## **Kern River No. 1 Hydroelectric Project (FERC Project No. 1930)**

#### **VOLUME 2 (PART 2d)**

**APPENDIX E.4**  
**Consultation Documentation**

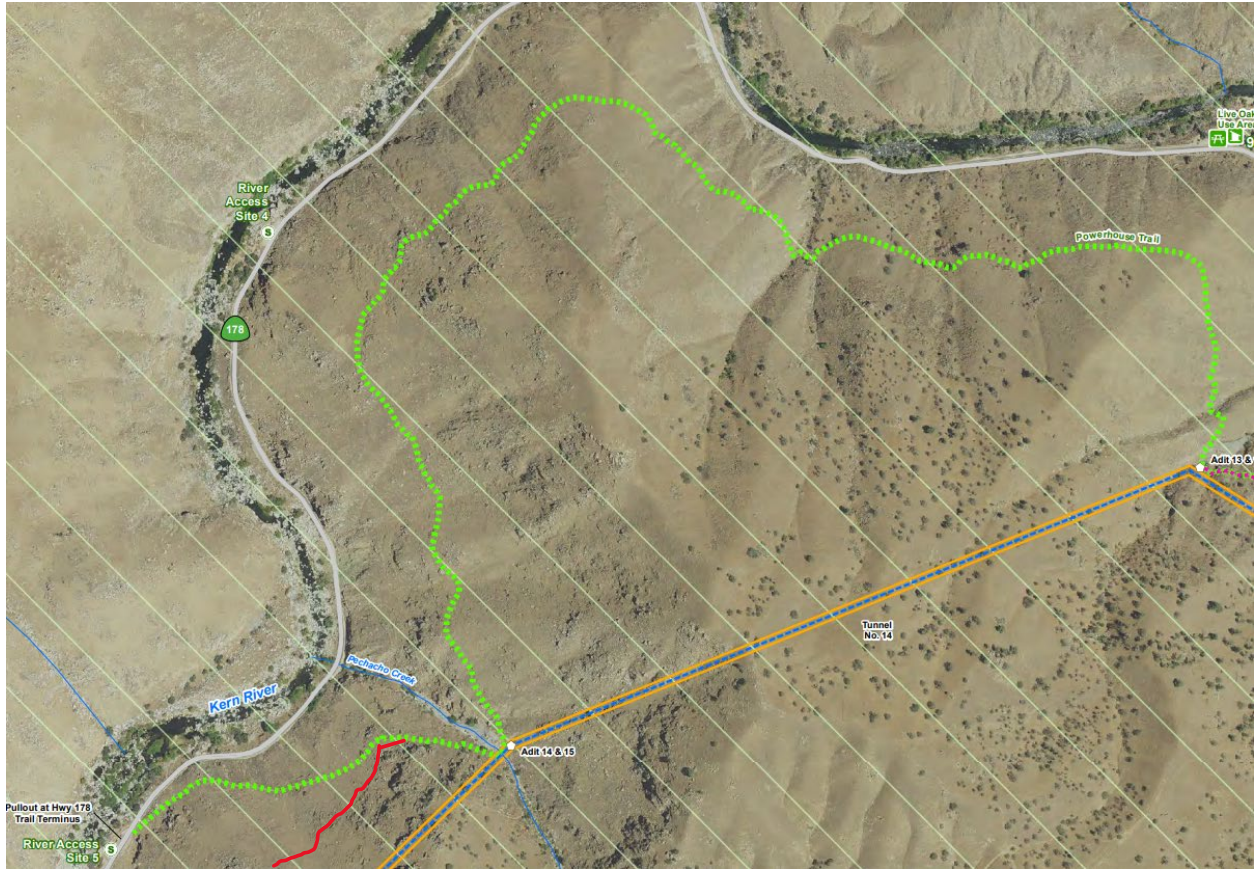
Figure 4. Map from REC-2 TM (p. 53) with red lines added showing trail segments not included in SCE's mapping. The Powerhouse Trail connects Adit 14 & 15 and Adit 13 & 14 and is in poor condition in this section. These segments should be included in a Recreation Trail Management Plan. (Source: SCE REC-2 TM, December 2025; annotations by Kern Gateway Trail Committee)

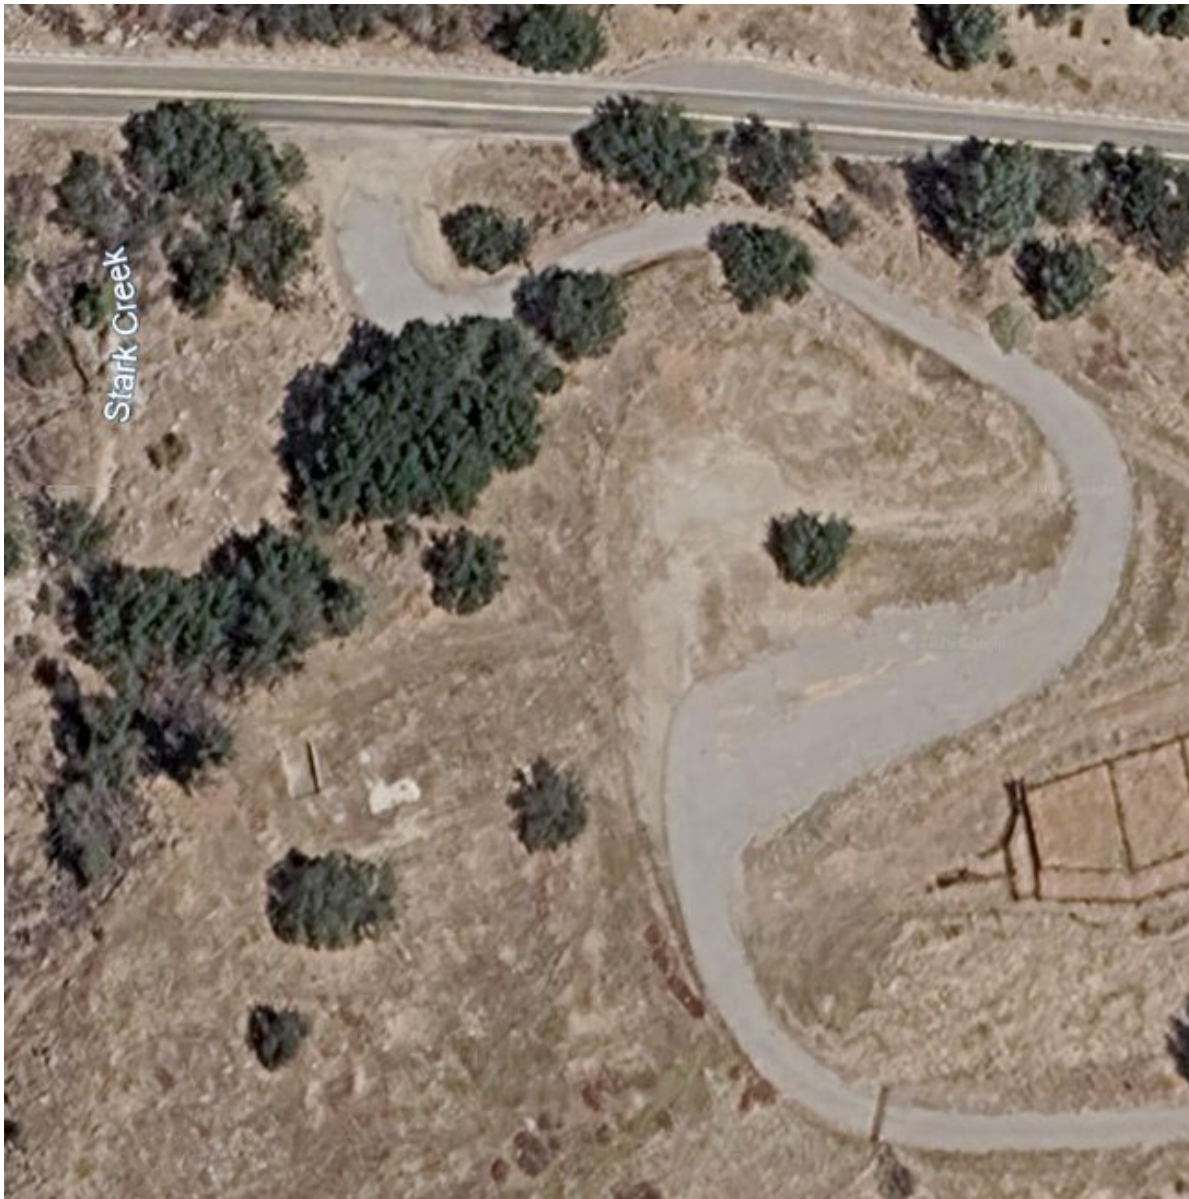
#### **D. REC-2 TM, Table 5-21 / Figure 5-5: The Lowest-Use Trail in the Study Had a Physical Obstruction at Its Trailhead Throughout the Entire Study Period**

A barbed wire fence across the Lucas Creek Trail trailhead presents a physical obstacle to hikers seeking to use this project trail. SCE acknowledges the Lucas Creek Trail as a formally designated project trail and installed a trail counter to measure use. The Lucas Creek Trail recorded the lowest use counts of any surveyed trail. The presence of

barbed wire at the trailhead throughout the study period likely deterred potential hikers, and the resulting low counts should be understood in that context rather than as evidence of low inherent demand.
